Check of wiring for actuator

SL2019-678/JNN August 2019

Concerns

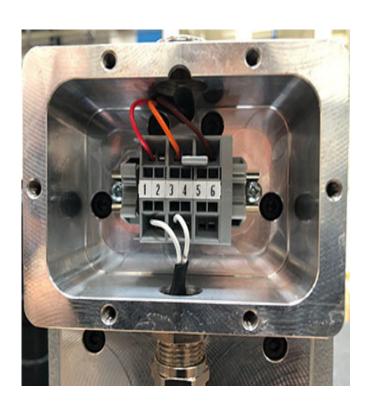
In the cases reported, an insulation failure has occurred on the wiring connecting the control module to the speed actuator. The cause for the insulation failure has been located to the wiring in the terminal box on the actuator.

As a precaution, we recommend to inspect the wiring in the terminal box at the first opportunity. At the inspection, it must be checked that the connection is installed in such a way that the wires do not touch the cover of the connection box. In case of any signs of wear on the insulation of the wires, the damaged part is to be cut off. The connection terminals are of the spring-loaded type, ferrules may be applied at the cables, we however in this particular case recommend removing the cable ferrules, if installed, and connect the wires directly in the terminal strip.

After reconnecting the wires, it must be ensured that no wire can be in contact with the cover. Remove the six screws in the front cover of the actuator to get access to the terminal strip.

Correct wiring without wire ferrules
